TEB Fashions International Ltd (9265)

27.MARCH.2014

ACCORD
on Fire and Building Safety in Bangladesh

Identified Priority 1 Concerns

Excessive Storage Height on Level 5

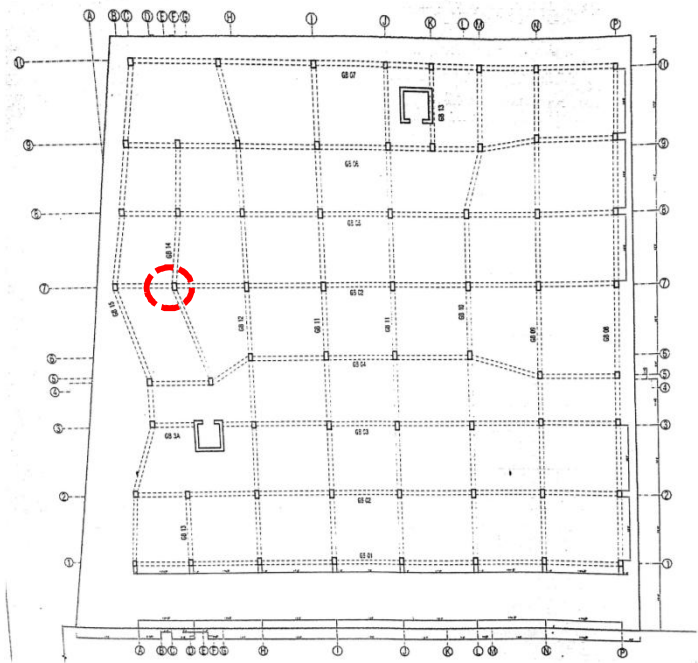
Each roll of fabric is estimated to be approximately 30kg. As they are stacked 8 rolls high, and arranged 7 rolls per layer, the weight of each layer is approx 210kg, resulting in a total weight of 1680kg (16.5kN) per stack.

Based on a plan area of 1.5m x 1.5m per stack, the equivalent live load per stack is estimated to be:

$$16.5\text{kN} / (1.5 \times 1.5)\text{m}^2 = 7.33\text{kPa}.$$

The allowable live load is max. 3.0kPa

Storage area on Level 5 appeared to have stored materials exceeding the permissible floor load.

- Redistribute fabric rolls around the floor area to ensure that no stack exceeds 300kg/m²

- Implement loading plan and oversee that storage of finished goods and raw materials are stored in accordance with the loading plan.

- Maintain loading plan

Rebar of Column C3 is not in accordance with structural drawings

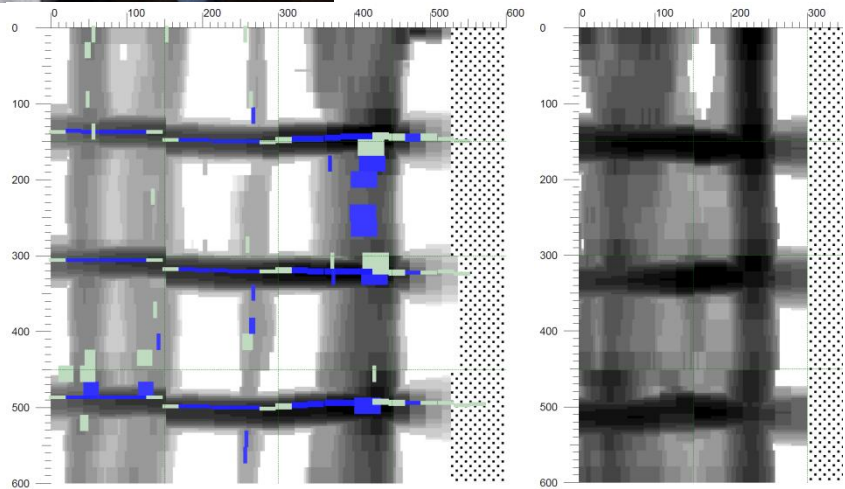
The original structural drawings denote that column C3 (circled in Red) has an RC detail of 24 no #6 bars. However, the ferroscope of the column at G/F level revealed only a maximum of 12 bars. Further investigations were carried out to determine the composition of the structure

The original drawings specify a concrete using stone aggregate, and using high-yield steel for the main bars, and mild-steel bars for the ties and links. It was noted on the roof floor that high-yield bars were used, but the concrete used contained brick aggregate.

In addition to the ferroskan, exposing the rebar also appeared to indicate that the bar was mild steel instead of high yield steel, as no rib pattern was observed on the rebar.

With this in hand, and based on the observed loading conditions, i.e. imposed load of factory floor not envisaged to exceed 2.0kPa with the exception of the storage floor at level 5, the column load rundown returned an AMBER warning, meaning that there was a very small factory of safety remaining in the loading capacity of the column.

- 1) Brick aggregate instead of stone aggregate
- 2) Mild steel bars instead of high-yield steel bars
- 3) 12-#6 instead of 24 #6 rebars (19mm diameter)
- 4) Greatly reduced loading capacity

Reinforcement provision and concrete composition does not match with the record drawings. Load rundown shows that the concrete column is loaded to a very low factor of safety

- Factory Engineer to review design, loads and columns stresses in all areas
- Verify insitu concrete stresses either by 100mm dia. cores or existing cylinder strength data.

- A full structural survey of the building is to be carried out using intrusive and non-intrusive methods to ascertain the overall accuracy of the existing record drawings.
- All roof activities and buildings are to be terminated and demolished respectively

- Prepare new as-built drawings and a new loading plan for each floor which should be maintained and monitored regularly
